MILITARY SPECIFICATION SHEET

CAPACITORS, FIXED, PLASTIC DIELECTRIC, DC,
IN NONMETAL CASES, ESTABLISHED RELIABILITY,
STYLE CFR04

This amendment forms a part of Military Specification Sheet MIL-C-55514/3C, dated 20 January 1971, and is approved for use by all Departments and Agencies of the Department of Defense.

FIGURE 1, Radial style, delete and substitute:

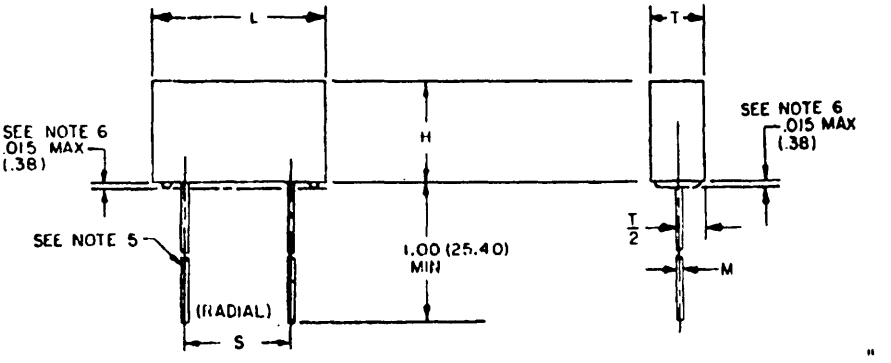
* FIGURE 1, NOTES: After note 6, add the following:

"7. Lead length of axial style may be a minimum of 1-inch long for use in tape and reel packaging when specified in the ordering data."
